STATE OF DELAWARE
DEPARTMENT OF TRANSPORTATION
800 BAY ROAD
P.O. BOX 778
DOVER, DELAWARE 19903

February 17, 2009

DelDOT Contract Number: 95-090-01; Federal Aid Project Number: IM-N056(27)
I-95 Delaware Turnpike Improvements Project
I-95/SR 1 Interchange/I-95 Turnpike Mainline
Turnpike Mainline from SR 1 to SR 141; I-95/SR 1 Interchange; I-95 Northbound
Widening Extension
New Castle County, Delaware
Environmental Reevaluation [*Change in interchange design*]

Figure A.5: I-95 Widening “Modified Design” Visual Screen Fence Envelope Sketch

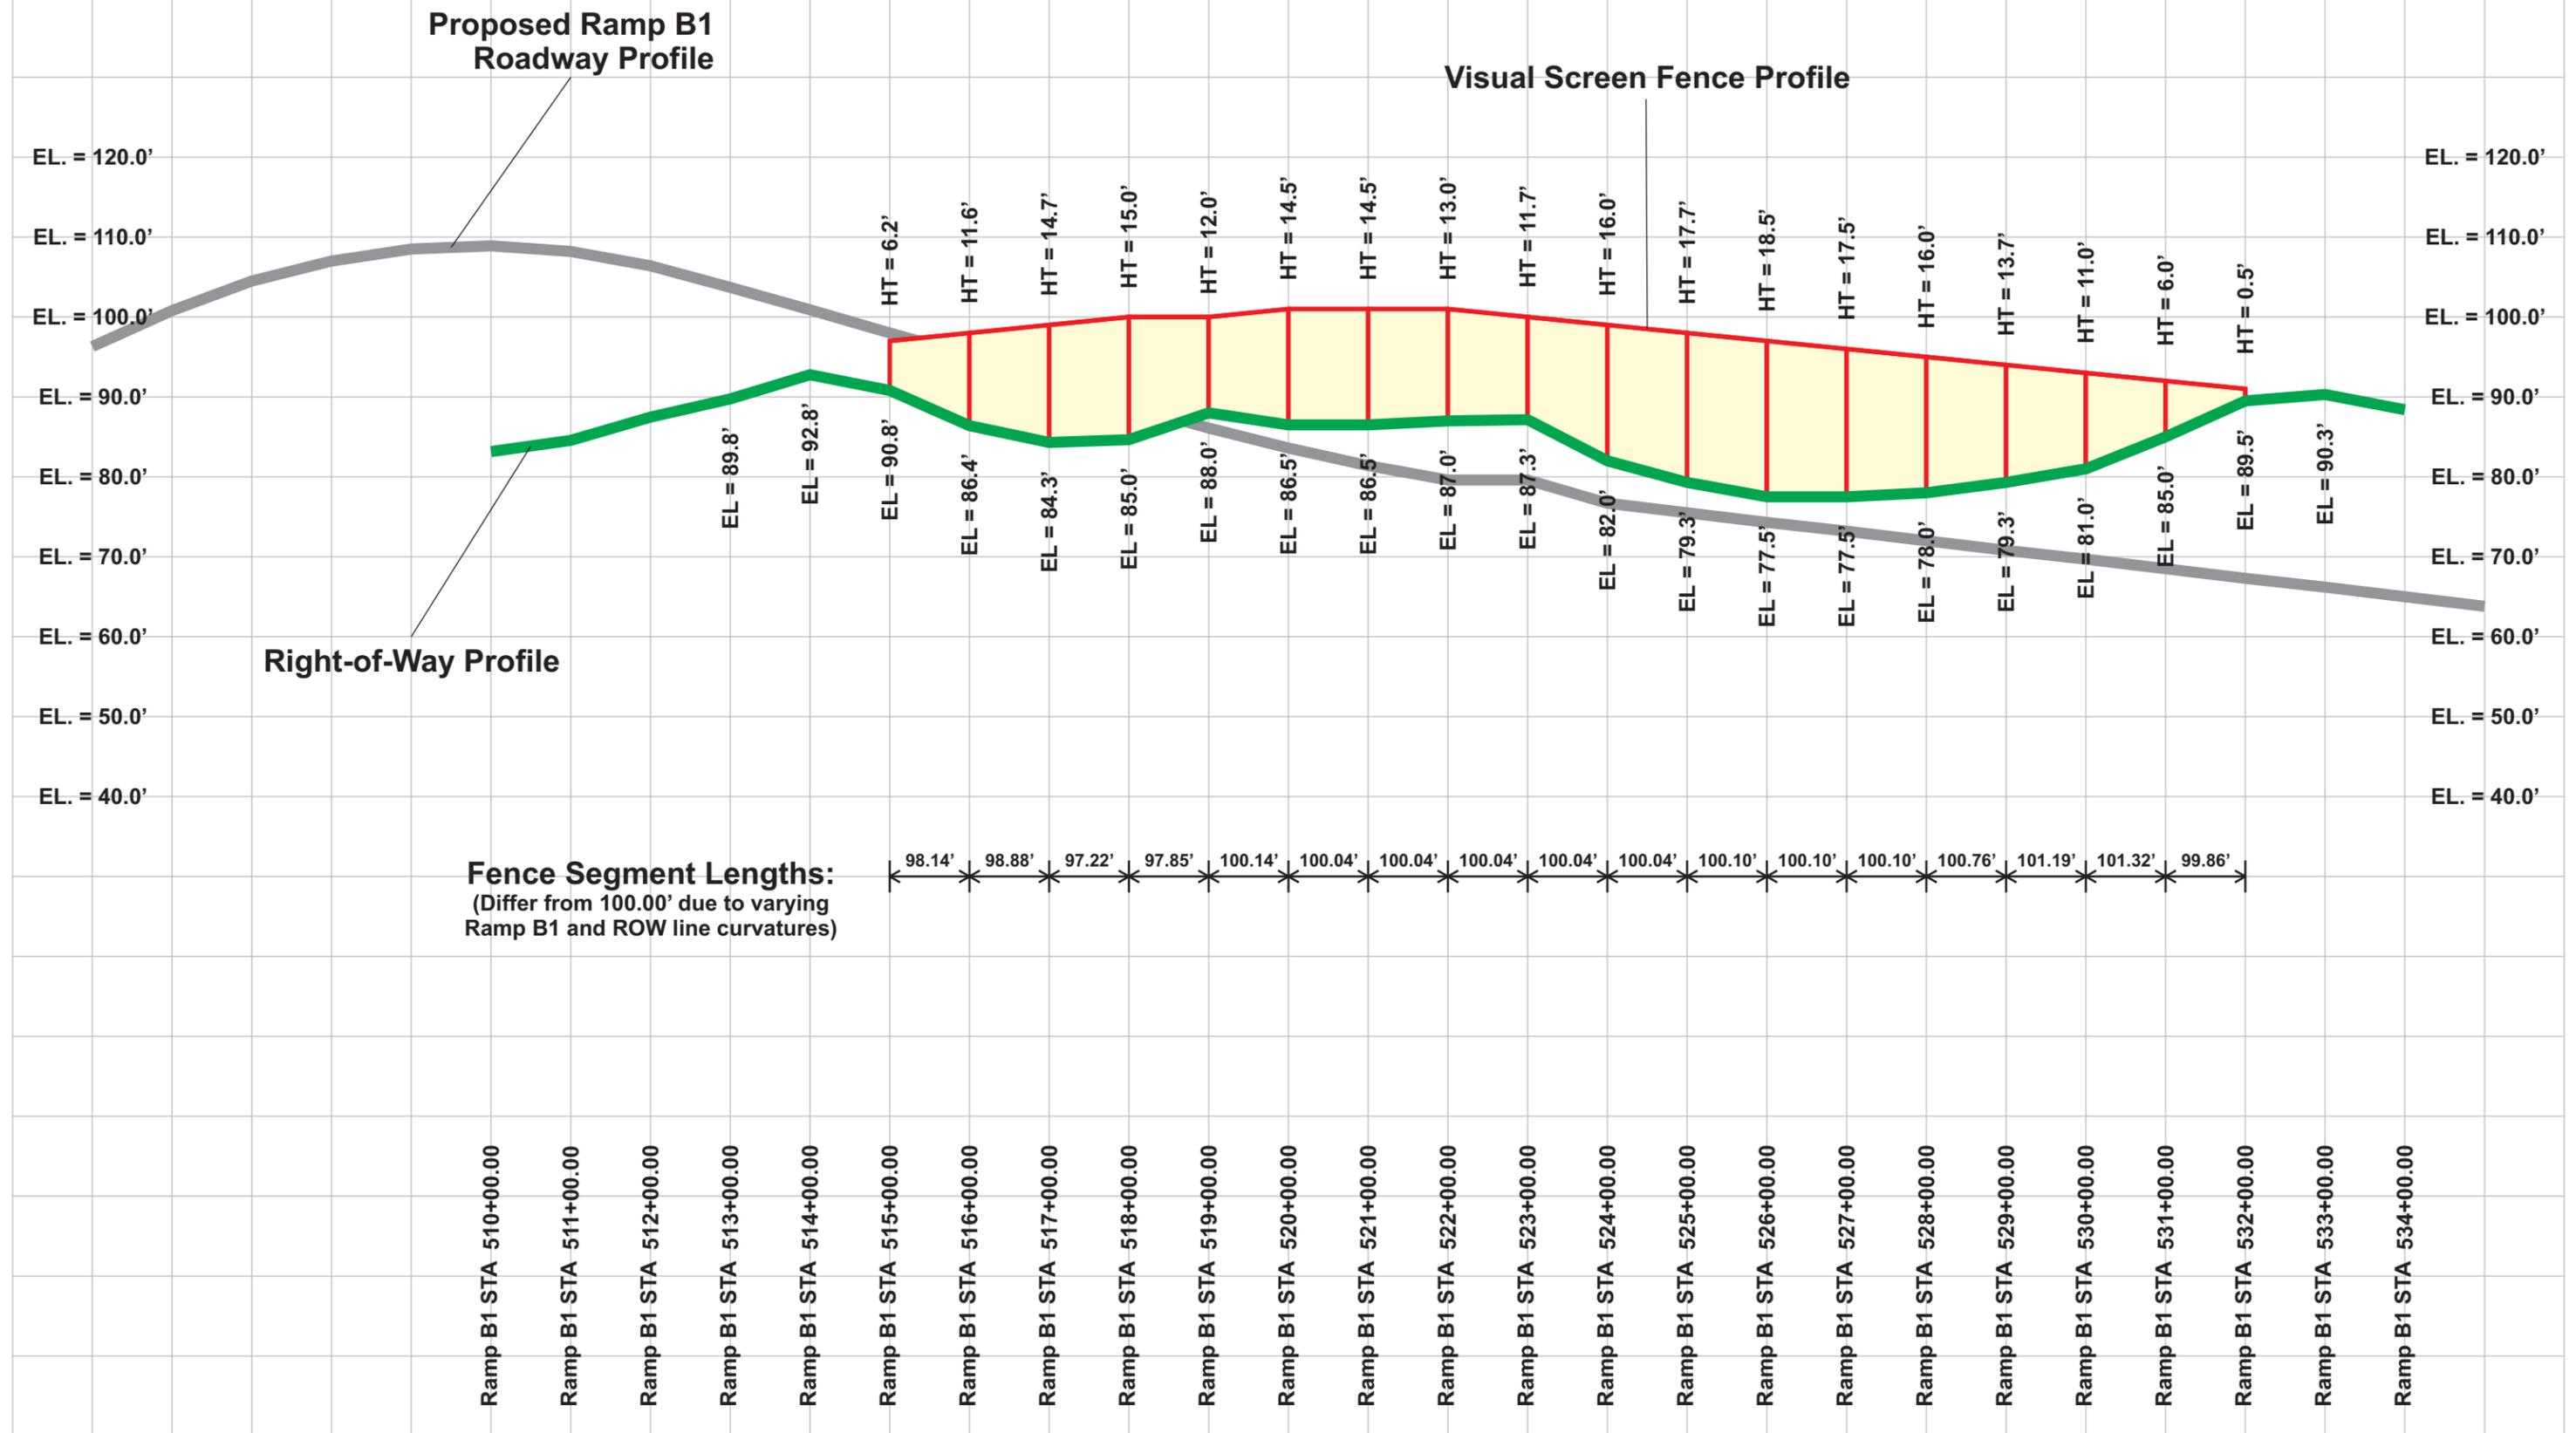
Although noise mitigation is not recommended in conjunction with the modified design, if constituted of materials certified and rated to reduce sound transmission, a visual screening fence constructed along the right-of-way limits would provide reductions below Build condition traffic noise levels to residences within the study area. Based on the predicted noise level reductions of an FHWA-approved solid noise wall, such a fence would provide at least five decibels of traffic noise level reduction to all design year 2030 Build condition traffic noise impacts, as shown in **Table A.3**, on page 9, if it were approximately 1,700 feet long and approximately 23,000 square feet, as shown in **Figure A.5** on page 15, and as described in **Table A.4**, on page 10.
